ELIMINATION OF ARBITRARY INTERMEDIATE PIPE BREAKS
HOPE CREEK GENERATING STATION
DOCKET NO. 50-354

Public Service Electric and Gas Company requests approval for the Hope Creek Generating Station to eliminate the postulation of intermediate pipe breaks as specified by SRP 3.6.2 Sections II.1 and II.2 unless such locations exceed the stress and usage factor threshold levels provided in BTP MEB 3-1 or are located in the proximity of welded pipe attachments.

In addition to the above information, attached for your review are proposed FSAR changes to Sections 1.11 and 3.6 eliminating the postulation of arbitrary pipe break locations. These changes will be incorporated upon approval of the above request.

MOORE CREEK
GENERATING STATION
FINAL SAFETY ANALYSIS REPORT
FEEDWATER PIPING ISOMETRIC
PORTION OUTSIDE PRIMARY
CONTAINMENT
FIGURE 1.3-14
REVISION 1, 06/80

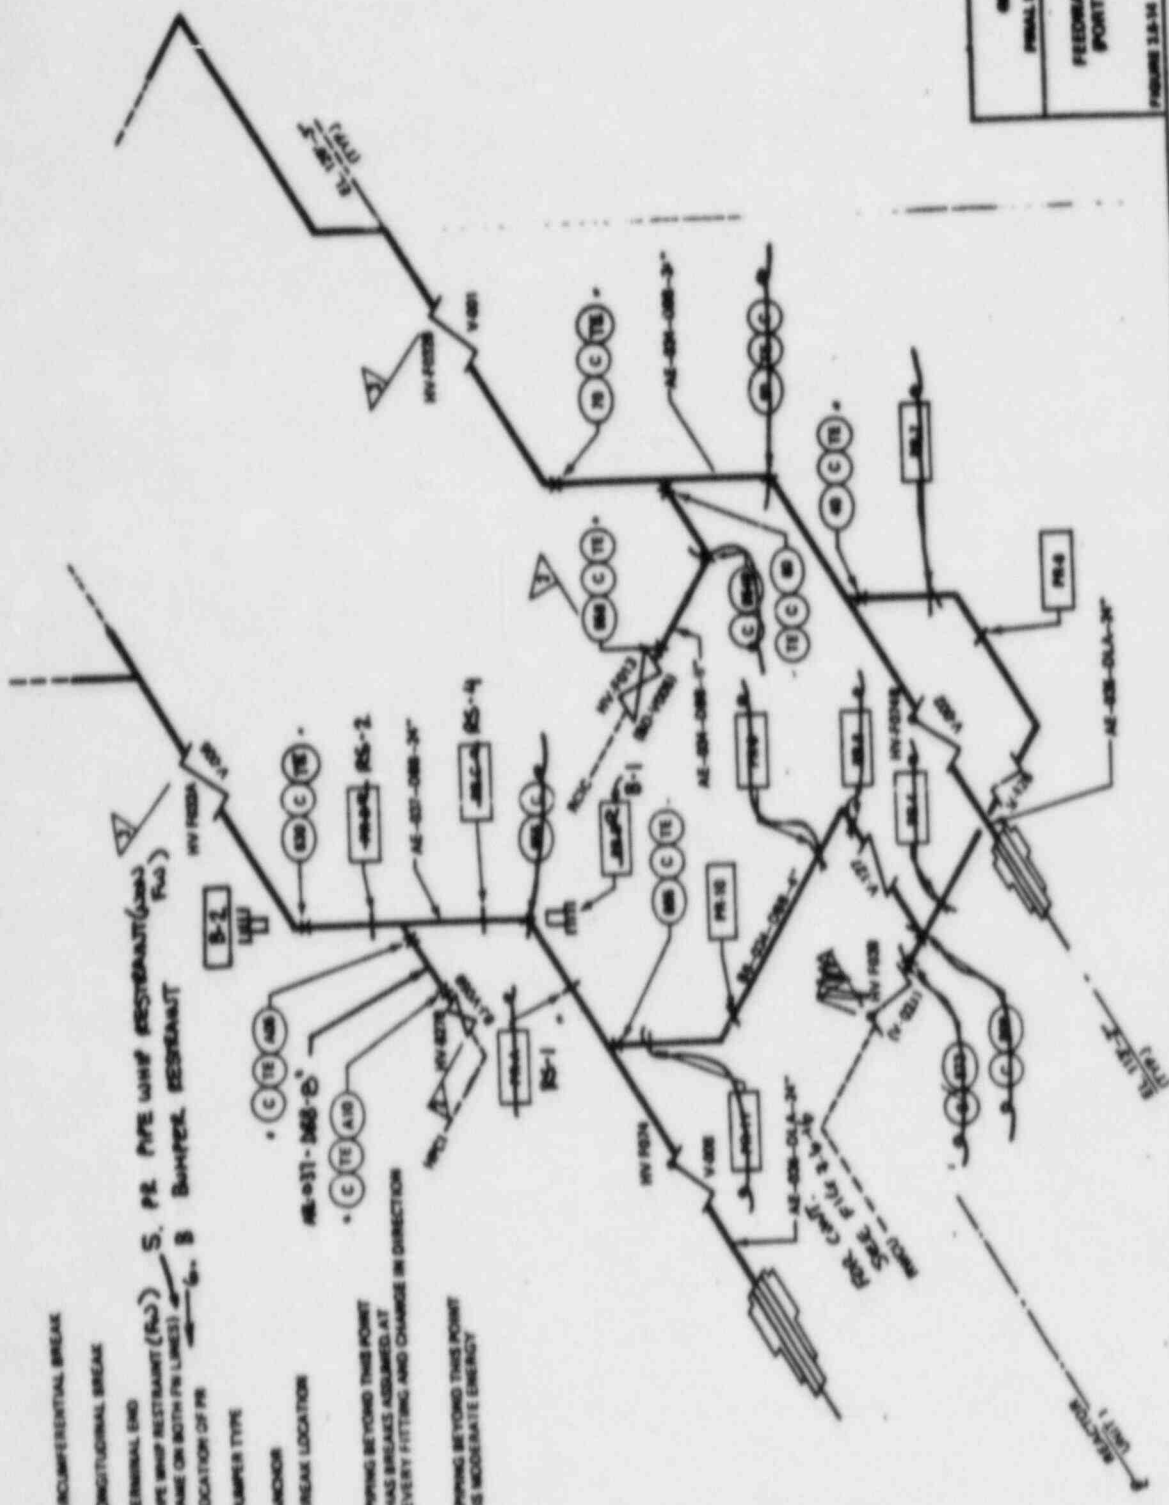
Node Point ⁽¹⁾	Node Type ⁽²⁾	Total Stress (ksi)	Pipe Break Stress Limit $0.8(1.2 S_y + S_a)$ (ksi)	Break Type ⁽³⁾	Basis for Break Selection ⁽⁴⁾
Line from F.W. ISO: Valves					
50	EL	8.31	32.40	C	TE
70	EL	3.31	32.40	C	MBL TE
655	EL	8.73	32.40	C	TE
630	EL	9.84	32.40	C	MBL TE
Line from HPCI pump disch.					
A05	BW	21.45	32.40	C	TE
A10	BW	21.02	32.40	C	TE
Line from RCIC pump disch.					
60	BW	17.04	32.40	C	TE
954	EL	18.51	32.40	C	MBL
958	BW	28.74	32.40	C	TE
Line from RWCU					
40	BW	16.33	32.40	C	TE
665	BW	12.07	32.40	C	TE
868	TEE	19.53	32.40	C	MBL
873	BW	20.54	32.40	C	MBL

-
- (1) Locations of the nodes are shown in Figure 3.6-14
 - (2) Symbols used to denote the node type are as follows:
 - EL - Elbow
 - TEE - Tee
 - BW - Butt weld
 - (3) Break types are indicated as follows:
 - C - Circumferential
 - (4) Symbols used to denote the basis for break selection are as follows:
 - TE - Terminal end
 - ~~MBL - Intermediate break locations selected to satisfy the requirements for a minimum number of break locations.~~
 - SFL - Stress and fatigue limits established in Section 3.6.2.1.1.3 are not met.
-

HPCL CHIEF GENERATING STATION FINAL SAFETY ANALYSIS REPORT	FIGURE 3.8-19	ASME	18-84
HPCL STEAM SUPPLY PIPING ISOMETRIC PORTION OUTSIDE PRIMARY CONTAINMENT.

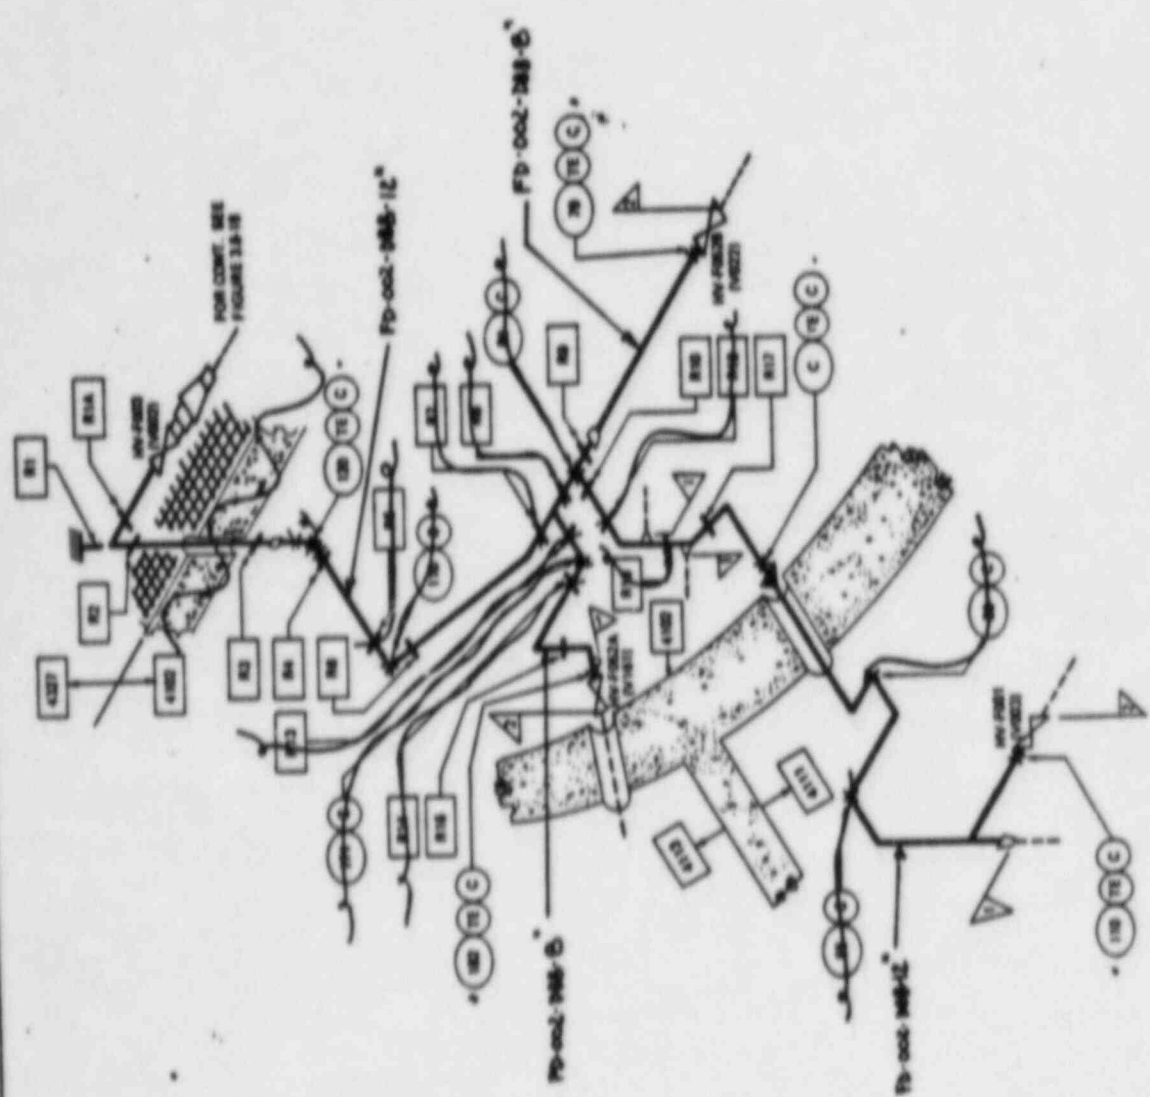
<u>Node Point(1)</u>	<u>Node Type(2)</u>	<u>Total Stress (ksi)</u>	<u>Pipe Break Stress Limit $0.8(1.2 S_h + S_a)$ (ksi)</u>	<u>Break Type(3)</u>	<u>Basis for Break Selection(4)</u>
Pump Discharge					
(see Feedwater and Core Spray)					
Turbine Steam Supply					
79	BW	12.79	32.40	C	TE
89	TEE	16.60	32.40	C	MBL
110	EL	16.37	32.40	C	MBL
120	EL	10.58	32.40	C	TE
C	ANCH	20.72	32.40	C	TE
171	EL	26.79	32.40	C	MBL
182	BW	8.84	32.40	C	TE
110	BW	10.16	32.40	C	TE
55	EL	7.98	32.40	C	MBL
20	EL	7.54	32.40	C	MBL

TE - Terminal end
~~MBL~~ - ~~Intermediate break locations selected to satisfy~~
~~the requirements for a minimum number of break~~
~~locations.~~

KOPE CREEK
GENERATING STATION
FINAL SAFETY ANALYSIS REPORT
MAIN STEAM DRAIN PIPING
ISOMETRIC PORTION OUTSIDE
PRIMARY CONTAINMENT
FIGURE 3.8-27
SHEET 1 OF 2
AMENDMENT A, MAIN

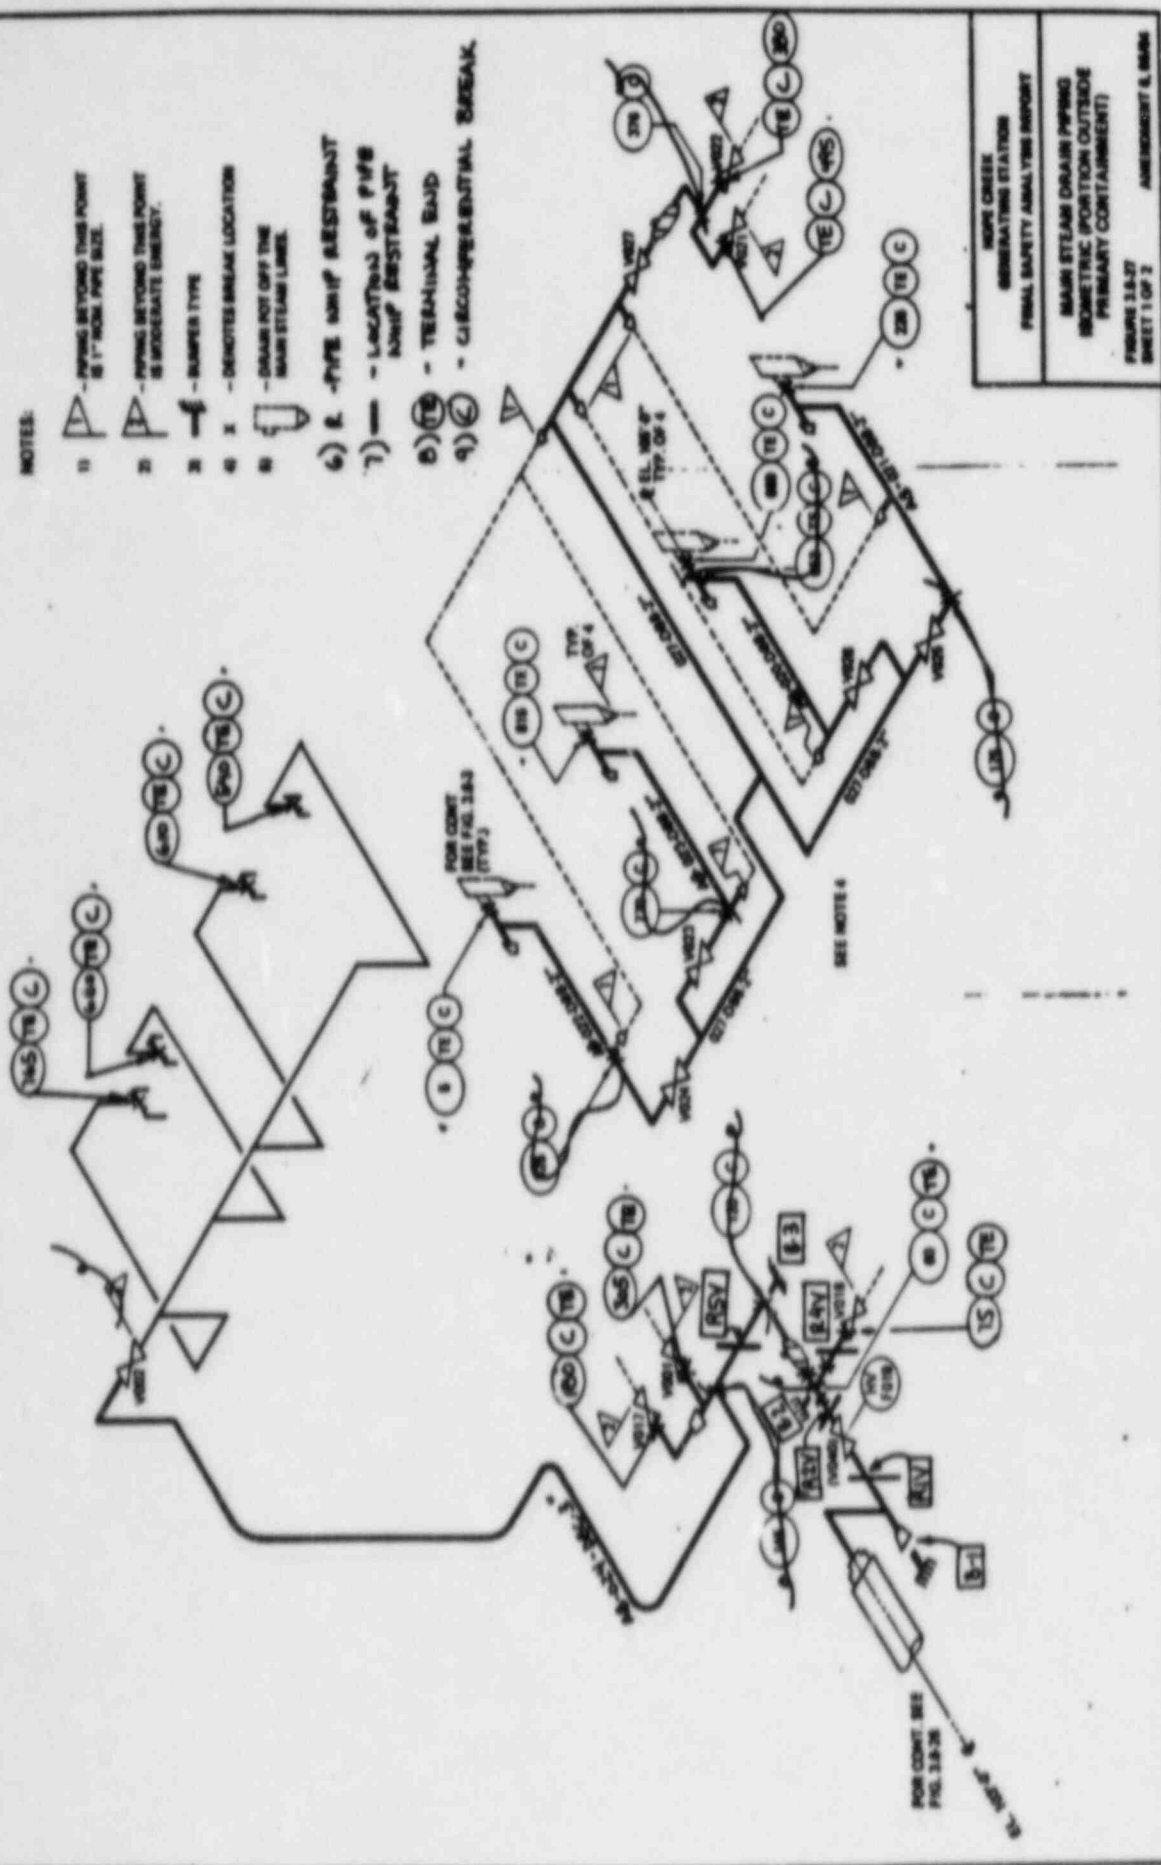
Node Point (1)	Node Type(2)	Total Stress (ksi)	Pipe Break Stress Limit $0.8(1.2S_h + S_a)$ (ksi)	Break Type(3)	Basis for Break Selection(4)
60	TE	12.26	32.40	C	TE
120	EL	13.25	32.40	C	MBL
145	TEE	12.09	32.40	C	MBL
5	BW	27.33	32.40	C	TE
925	TEE	25.15	32.40	C	MBL
770	TEE	25.32	32.40	C	MBL
815	BW	21.31	32.40	C	TE
652	TE	20.82	32.40	C	MBL
660	BW	23.20	32.40	C	TE
175	EL	14.94	32.40	C	MBL
225	BW	17.15	32.40	C	TE
376	TE	16.17	32.40	C	MBL
160	EL	11.81	32.40	C	TE
740	TEE	6.07	32.40	C	TE
585	TEE	8.56	32.40	C	TE
425	TEE	8.05	32.40	C	TE

~~MBL - Intermediate break locations selected to satisfy the requirements for a minimum number of break locations.~~

<u>Node Point (1)</u>	<u>Node Type (2)</u>	<u>Total Stress (ksi)</u>	<u>Pipe Break Stress Limit $0.8(1.2S_h+SA)$ (ksi)</u>	<u>Break Type (3)</u>	<u>Basis For Break Selection (4)</u>
765	BW	20.7	32.40	C	TE
680	BW	22.0	32.40	C	TE
610	BW	23.9	32.40	C	TE
540	BW	21.3	32.40	C	TE
275	BW	5.3	32.40	C	TE
345	BW	9.5	32.40	C	TE
75	BW	12.14	32.40	C	TE
180	BW	17.54	32.40	C	TE
305	BW	12.37	32.40	C	TE
380	BW	13.79	32.40	C	TE
495	BW	4.30	32.40	C	TE

FIGURE 3.3-28 AMENDMENT 8, 8/8/86

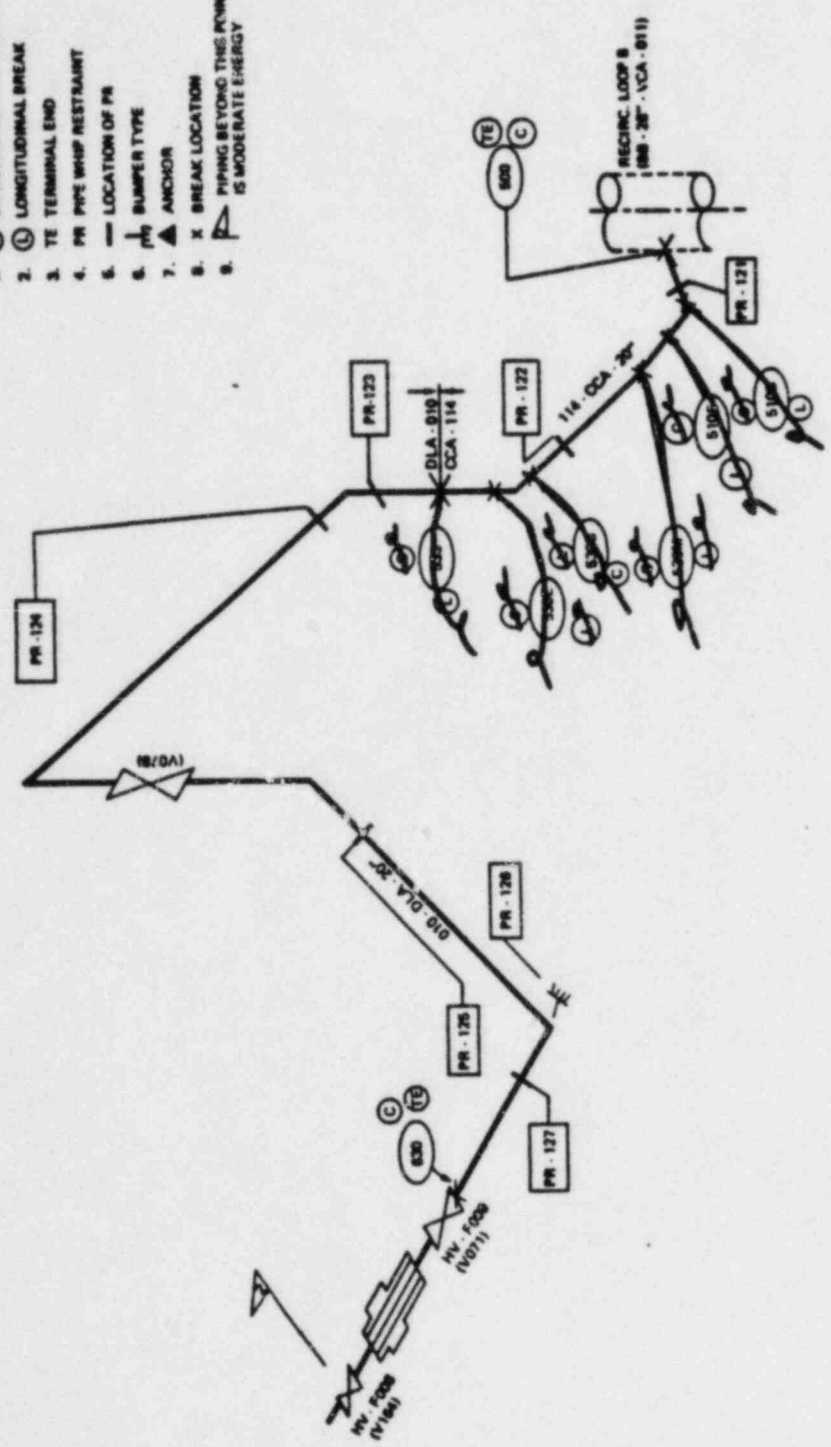
Node Point(1)	Node Type(2)	Stress By EQ. 10 (ksi)	Cumulative Usage Factor	Pipe Break Stress Limit 2.4 Sm (ksi)	Break Type(3)	Basis for Break Selection(4)
500	TTJ BW	46.8 39.77	0.0051 0.001	34.05 34.032	C	TE
510B	EL	85.27	0.655	34.032	C&L	SFL
510E	EL	85.27	0.655	34.032	C&L	SFL
520M	BE	61.39	0.133	34.032	C&L	SFL
530B	EL	72.08	0.365	34.032	C&L	SFL
530E	EL	72.08	0.365	34.032	C&L	SFL
533	TTJ	66.03	0.566	34.032	C&L	SFL
630	TTJ	47.87 34.5	0.0124 0.0188	42.86 42.375	C	TE

MOORE CREEK GENERATING STATION FINAL SAFETY ANALYSIS REPORT
RHR SHUTDOWN COOLING RETURN PIPING ISOMETRIC LOOP A
FIGURE 3.8-31 SHEET 1 OF 2 AMENDMENT 5, 06/04

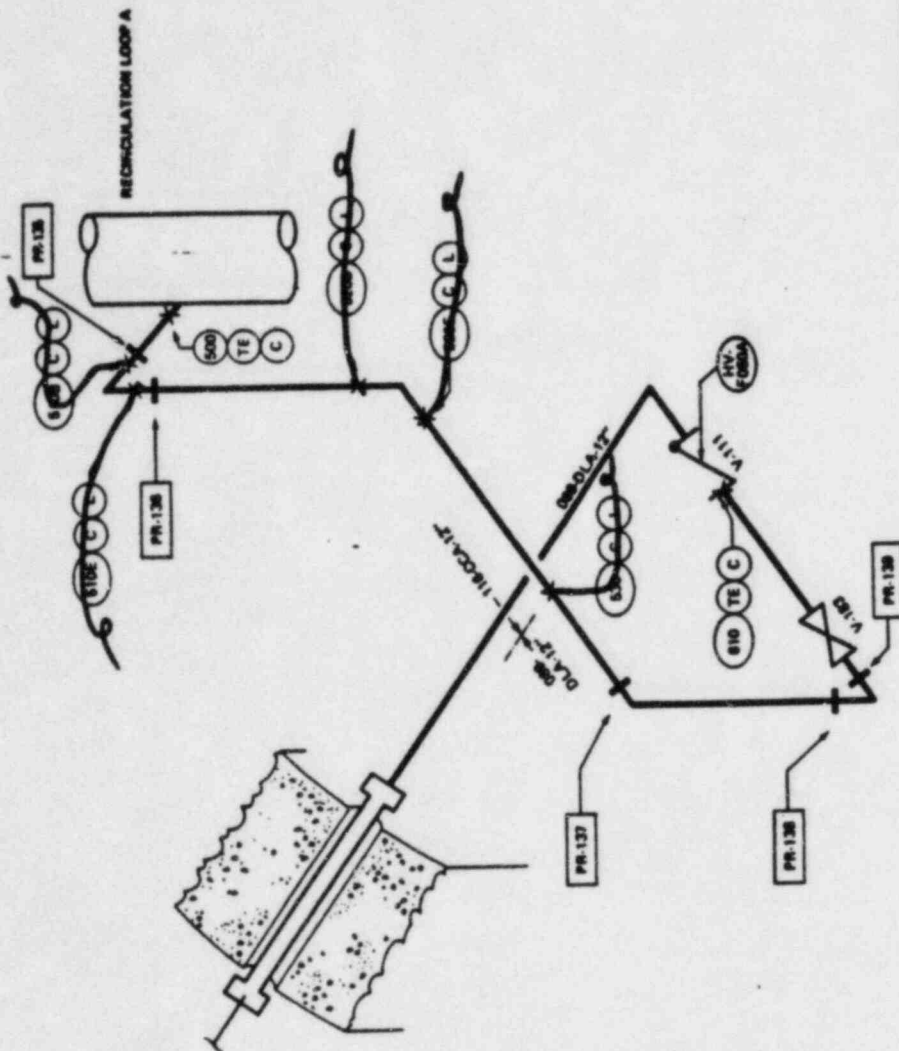
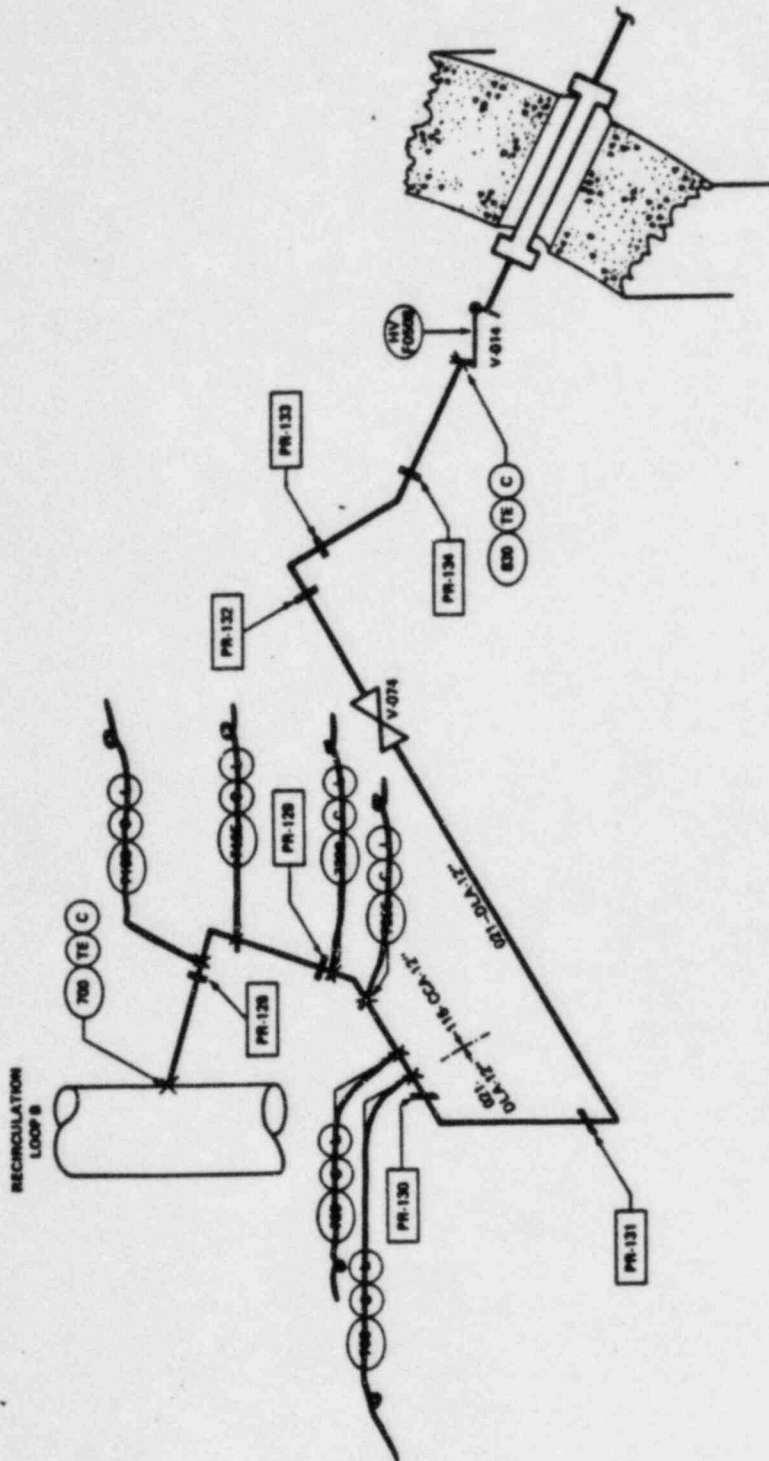
Node Point(1)	Node Type(2)	Stress By EQ. 10 (ksi)	Cumulative Usage Factor	Pipe Break Stress Limit 2.4 Sm (ksi)	Break Type(3)	Basis for Break Selection(4)
LOOP A 12"-CCA-116(SS) 12"-DLA-069(CSS)						
	TTJ	41.3	0.0196	34.05		
500	BW	62.116	0.4767	34.032	C	TE
510B	EL	59.398	0.3764	34.032	C&L	SFL
510E	EL	57.672	0.3206	34.032	C&L	SFL
520B	EL	57.814	0.3198	34.032	C&L	SFL
520E	EL	57.881	0.3211	34.032	C&L	SFL
530	TTJ	51.987	0.1688	34.032	C&L	SFL
610	TTJ	38.67	0.0133	42.864	C	TE
		30.1	0.0137	42.375		
LOOP B 12"-CCA-115(SS) 12"-DLA-021(CSS)						
	TTJ	46.6	0.0210	34.05		
700	BW	61.6	0.499	34.032	C	TE
710B	EL	50.09	0.441	34.032	C&L	SFL
710E	EL	58.56	0.376	34.032	C&L	SFL
720B	EL	59.23	0.378	34.032	C&L	SFL
720E	EL	58.9	0.355	34.032	C&L	SFL
725	STR	57.53	0.102	34.032	C&L	SFL
735	TTJ	50.91	0.161	34.032	C&L	SFL
830	TTJ	37.53	0.0136	42.86	C	TE
		28.9	0.0140	42.375

TE - Terminal end
~~MBL~~ - Intermediate break locations selected to satisfy
the requirements for a minimum number of break
